Land at South Farm, Wickwar

Landscape Addendum (February 2023)

edp6190_r009a

- 1.2 This is an addendum to the submitted Landscape and Visual Appraisal (LVA) (report ref. edp6190_r001) and associated plans and appendices. Changes to the layout have been made following receipt of comments from South Gloucestershire's Landscape Officer dated 06 April 2022 and the Design West Panel on 19 July 2022 (Reference: DWSG025) and consequently, these layout changes and resulting assessment updates are set out in this addendum.

DRAWING NUMBER: 3001 **CHECKED BY:** CD/LN

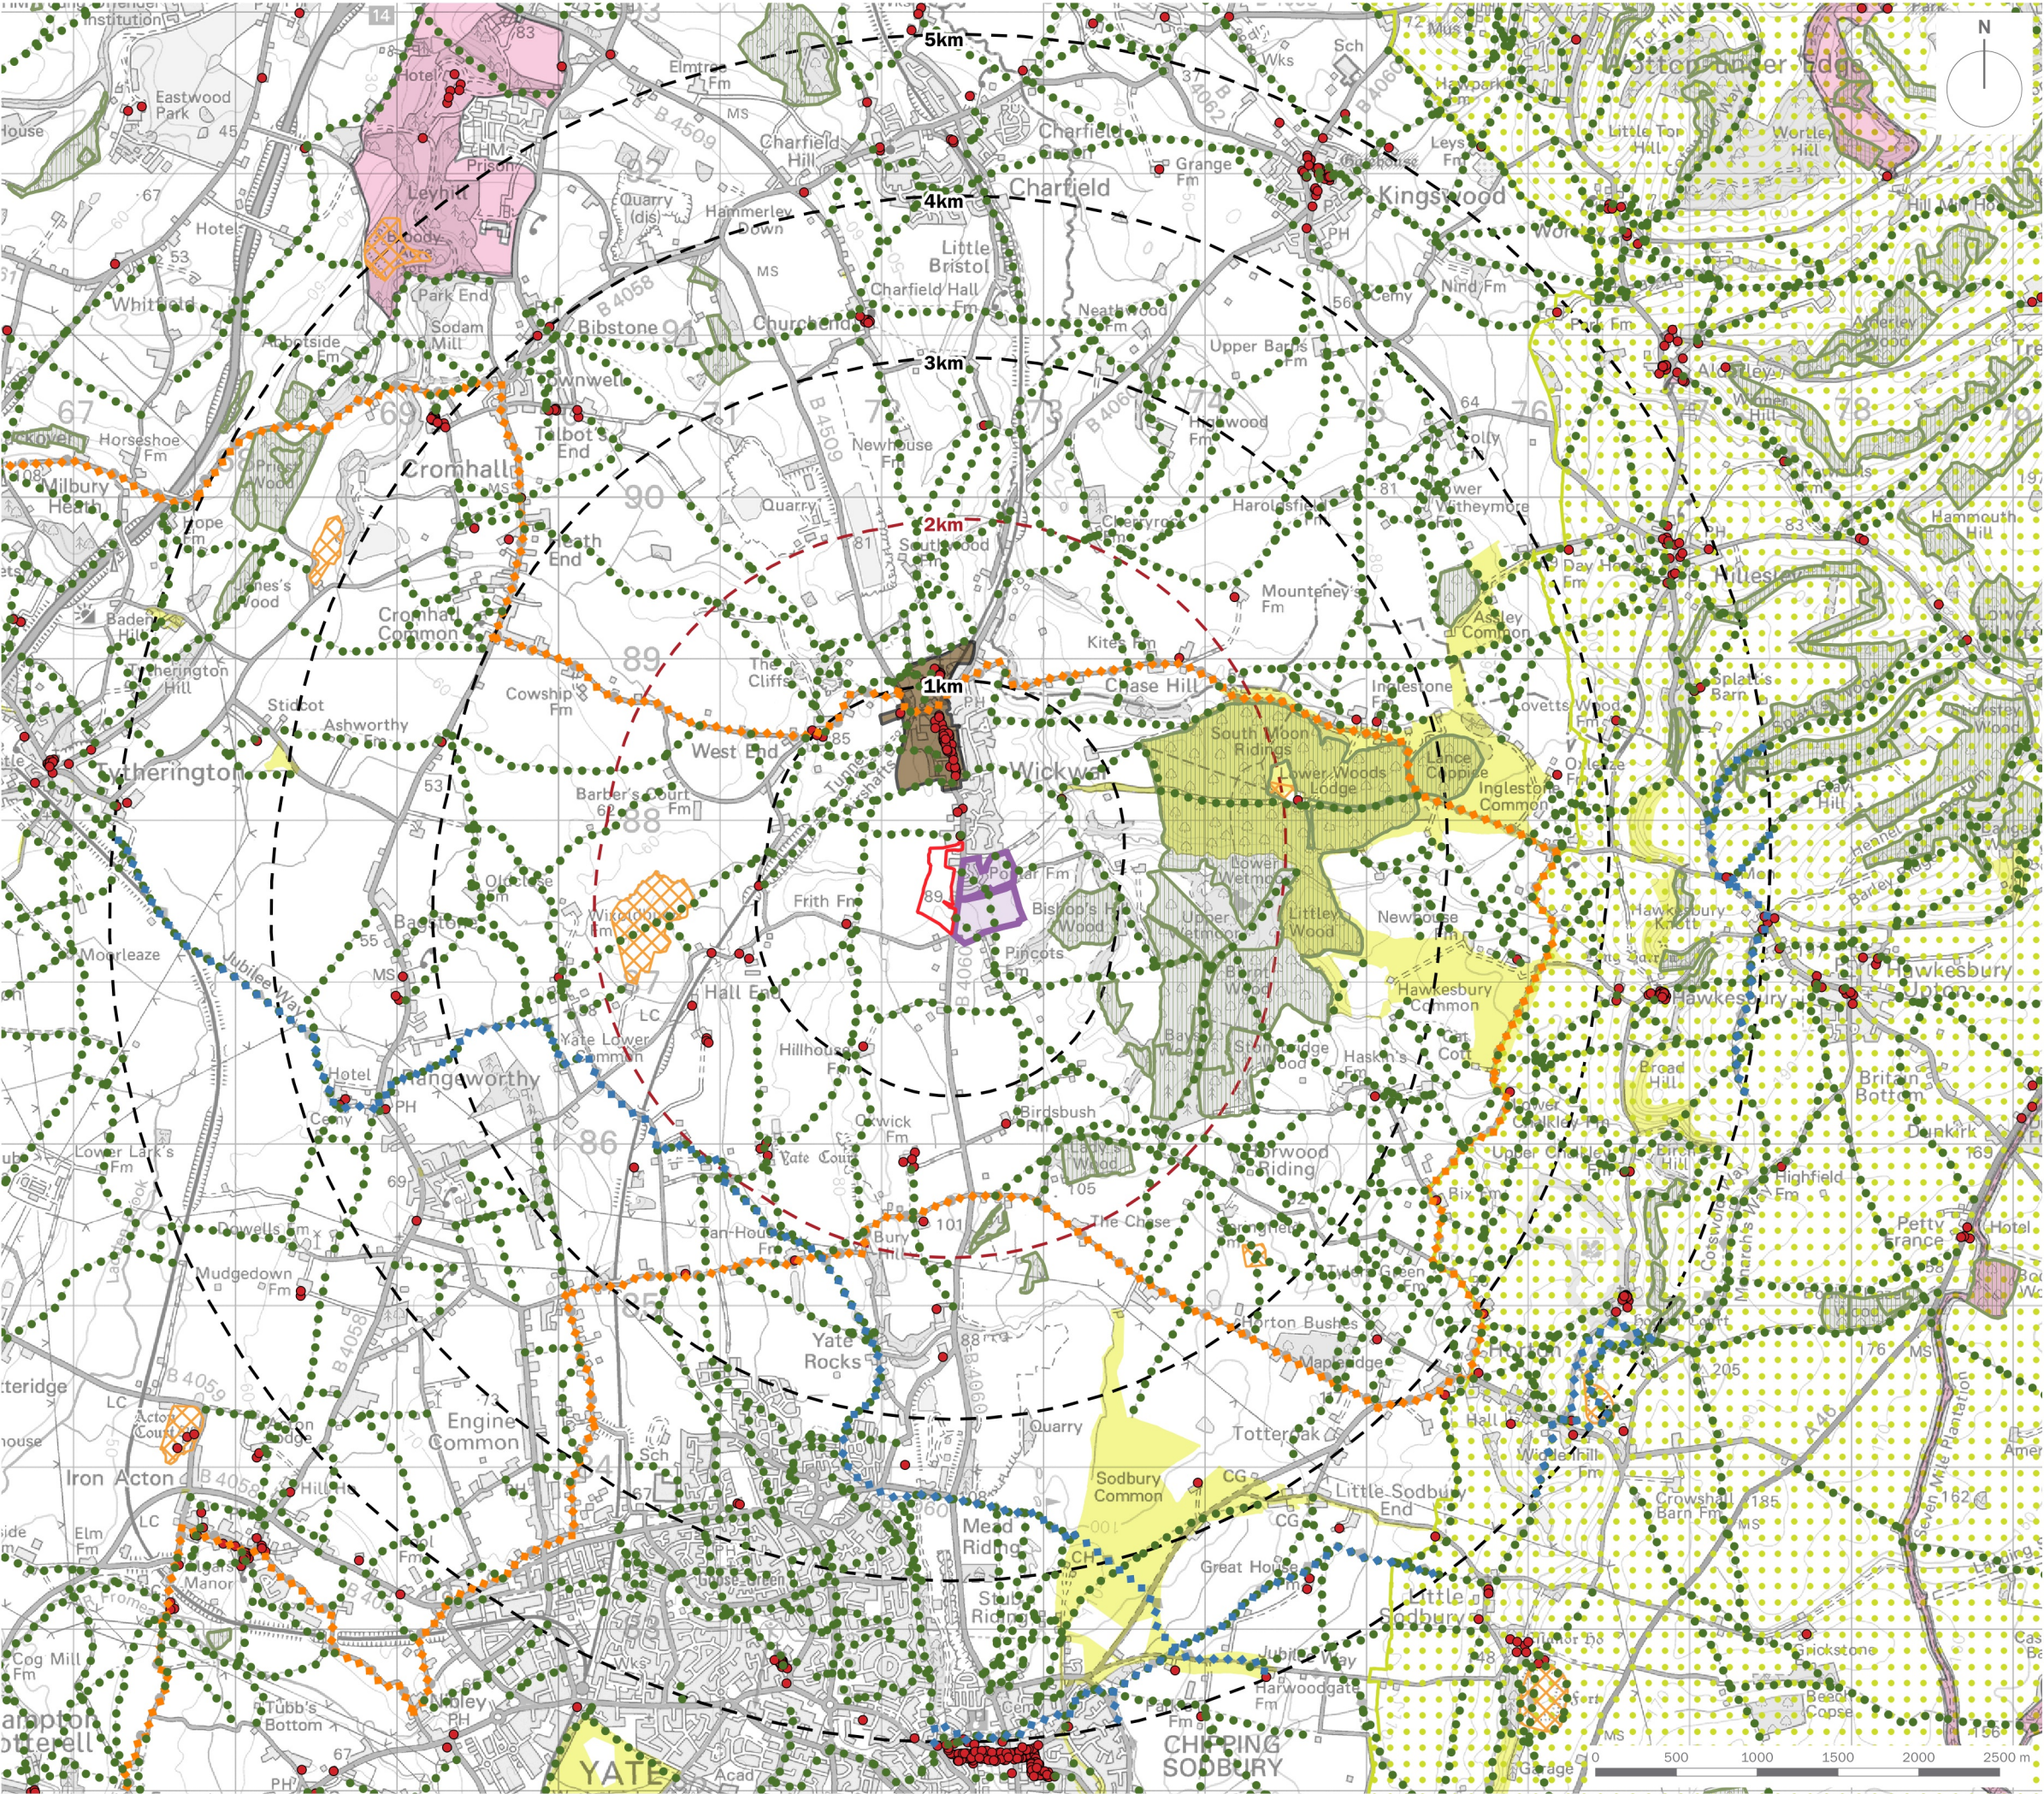
- *“Neither Framework Masterplan -3001 Rev. H or DAS Figure 25: GI Parameter Plan provide a sufficiently detailed landscape design and mitigation strategy plan.”;*

- *“The footprint of the 3no. blocks of proposed housing will encroach into the surrounding countryside. Additional tree planting strips are shown along sections of the northern and eastern boundaries DAS Figure 25: GI parameter Plan, but the design of the western or southern site boundary treatments do not demonstrate delivery of a well-designed, articulated green edge/buffer between the proposed housing and wider countryside.”; and*

3.1 Considering the comments outlined above, EDP have guided a number of landscape related changes to the revised scheme to provide a more landscape appropriate approach to the scheme’s layout. The revised layout is illustrated within the Framework Masterplan (Reference BLOA3039/3001/Rev M) included as **Appendix EDP 2**, and the following parameter plans produced by Turley:
